SAFETY EVALUATION BY THE OFFICE OF NUCLEAR REACTOR REGULATION
RELATIVE TO INSPECTION AND REPAIRS OF THE REACTOR
COOLANT SYSTEM PIPING

PILGRIM NUCLEAR POWER STATION
BOSTON EDISON COMPANY
DOCKET NO. 50-293

FIGURE 1 Complex Metallurgical Condition of
Safe End to Nozzle Attachment

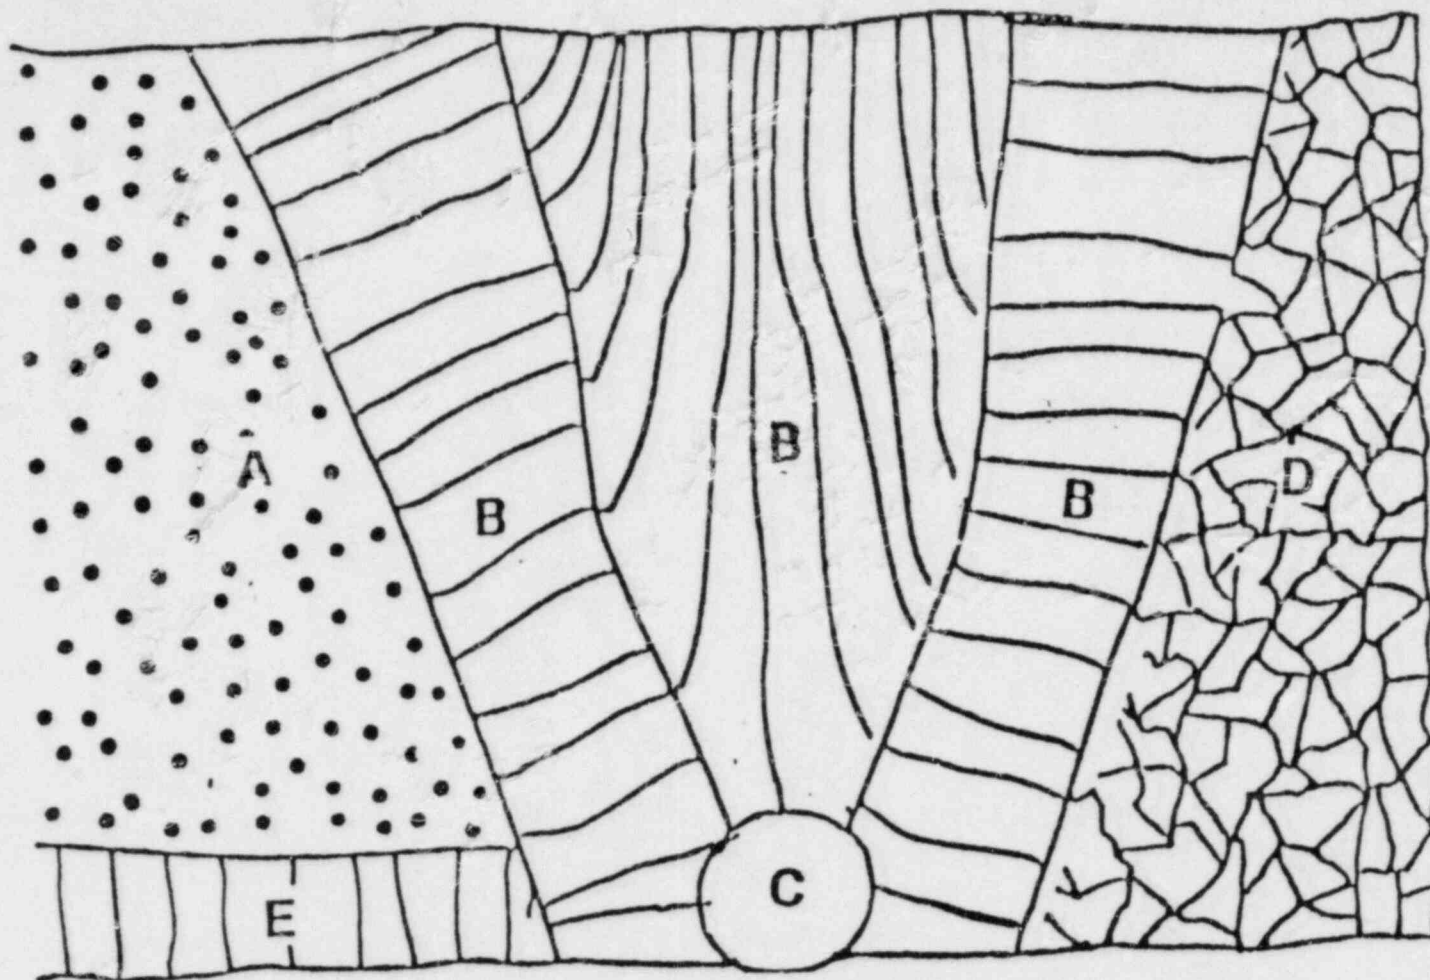
- (4) The field weld root between the 182 weld surfaced steel nozzle and the Inconel 182 weld surfaced solution annealed 304 stainless steel safe-end was made using the gas tungsten arc process with Inconel 82 weld metal. The gas tungsten arc process is used to weld the root of pipe joints because its ease of control produces higher quality in the difficult weld roots of these joints.
- (5) The rest of the weld was made using the shielded metal arc process with Inconel 182 weld metal (See Figure 1).

However, we noted that the cracked Inconel 182 weld butter on the three recirculation nozzles was repaired with the same materials, which will continue to be susceptible to IGSCC. Our acceptance of the repair program is based on the following considerations:

- (1) The cracks found on Inconel 182 weld butter are predominantly in the axial orientation and their lengths are limited within the region of the weld butter. The width of the repaired Inconel 182 weld butter is reported to be less than one half of an inch. Axial cracks of such a short length are not expected to have significant impact on the structural integrity of the nozzles.
